MILITARY SPECIFICATION SHEET

ADAPTER, CONNECTOR, COAXIAL, RADIO FREQUENCY,
(WITHIN SERIES BNC), CLASS 2, RIGHT ANGLE PLUG

This amendment forms a part of military specification sheet MIL-A-55339/14, dated 6 May 1975, and is approved for use by all Departments and Agencies of the Department of Defense.

FIGURE 2, delete and substitute:

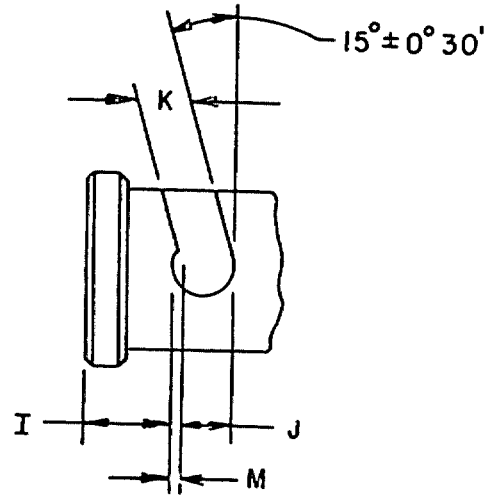
FIGURE 2, maximum column: Add dimension E ".230 (5.84)", dimension L ".040 (1.02)", and dimension P ".228 (5.79)".
